THE ORCHARD
SAN ANTONIO, TEXAS
MASTER DEVELOPMENT PLAN

MDP# 021-08

Re: **The Orchard** **MDP # 021-08**

The Development Review Committee has reviewed **The Orchard** Master Development Plan **M.D.P. # 021-08**. Please find enclosed an accepted and signed copy for your files. However, please note the following conditions:

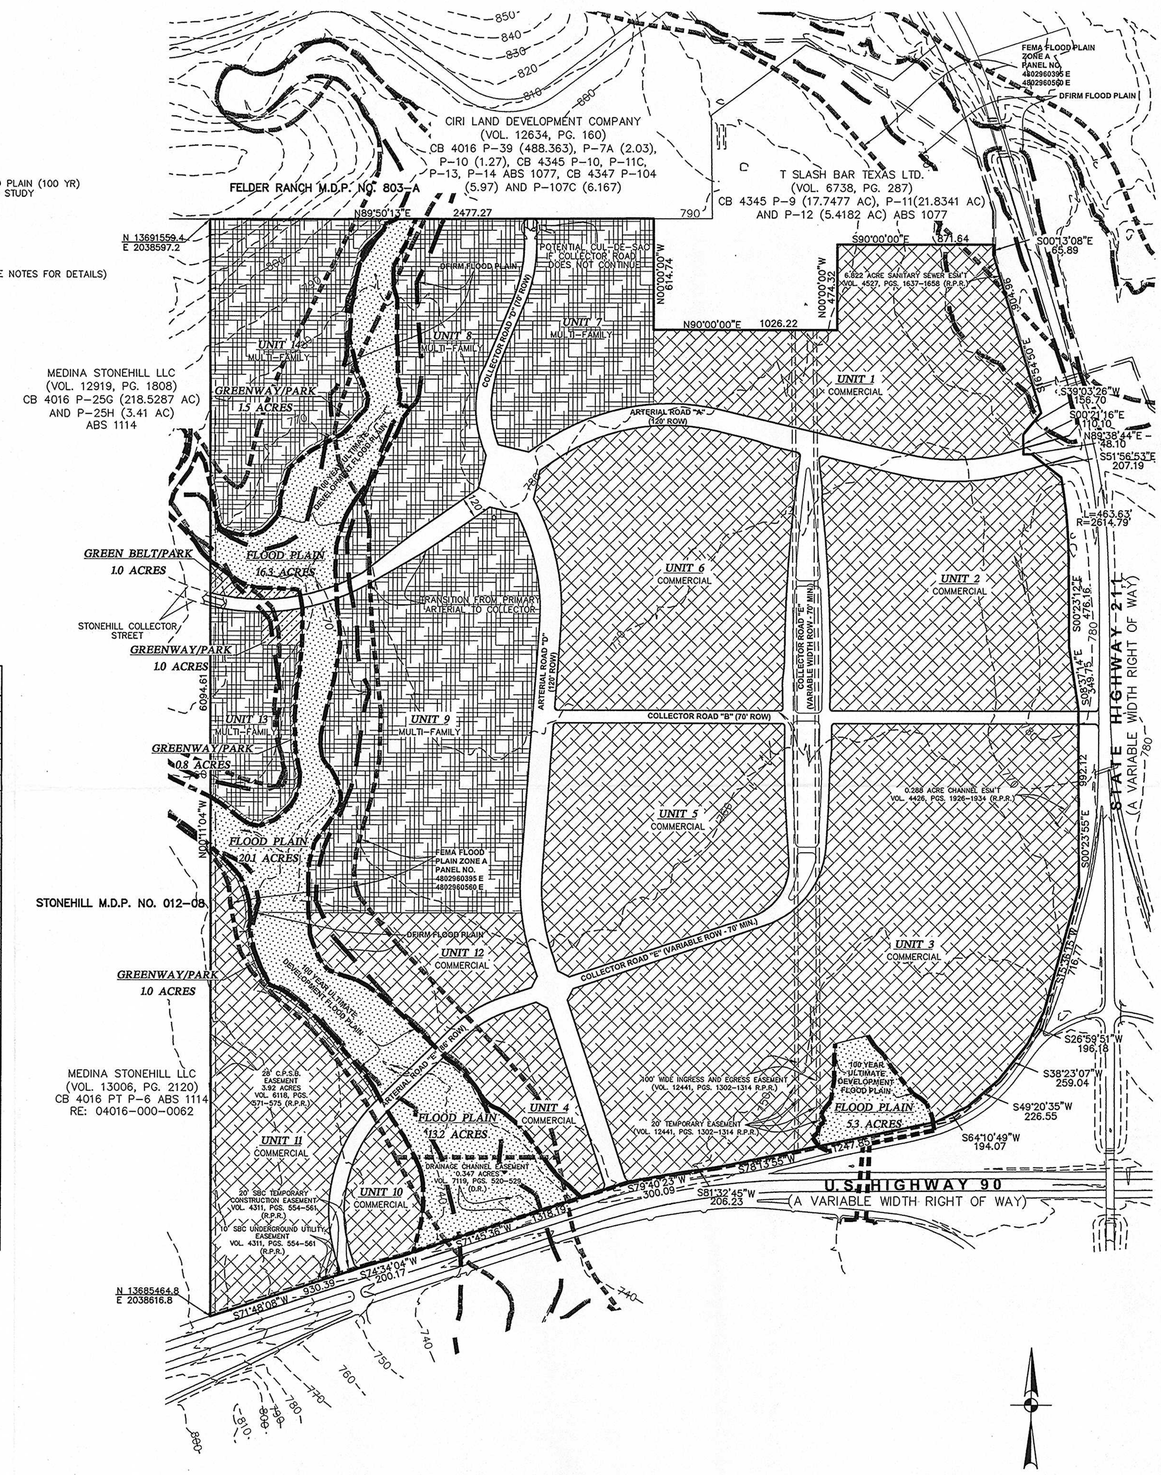
In consideration of public safety and convenience, excessive grades by reason of topography should be avoided in street layouts and arrangements. All platting shall comply with the Unified Development Code (UDC), Master Plan, Major Thoroughfare Plan, and all applicable regulations for the City of San Antonio. It will be expected that all of the property depicted in your Master Development Plan to include floodplains, drainage areas, and open space shall be platted. It is suggested to work closely with the school district, so they can plan accordingly. Any access and R.O.W. issues along state facilities will need to be resolved with the **Texas Department of Transportation (TXDOT)**. For information about these requirements you can contact TXDOT at 615-5814.

- Coordinate with the Texas Department of Transportation for improvements along SH 211 and US Highway 90.
- Right and left turn lanes may be required and should be designed according to TxDot standards. Any mitigation along US 90 and SH 211 should be coordinated with TxDot.
- TxDot will determine access points along US 90 and SH 211.
- Traffic controls shall be warranted as per the Texas Manual on Uniform Traffic Control Devices and approved by Bexar County and TxDot.

- The Texas Sites Atlas indicates that no archaeological sites have been previously identified within the above referenced property. However, the project area lies between the East Branch Big Sous Creek and Lucas Creek and there is a **high probability** that the property may contain sites, some of which may be significant. The project area is within the known 11 league grant for the Ranch de San Lucas, one of two 18th century Spanish ranchos for the Mission San Jose y San Miguel Aguayo. Thus, before any work that might affect any sites is begun, we recommend that a qualified professional conduct an archaeological investigation of the property. The investigation should be performed according to Archeological Survey Standards for Texas, and any previously identified sites should be reexamined and reevaluated, if any.
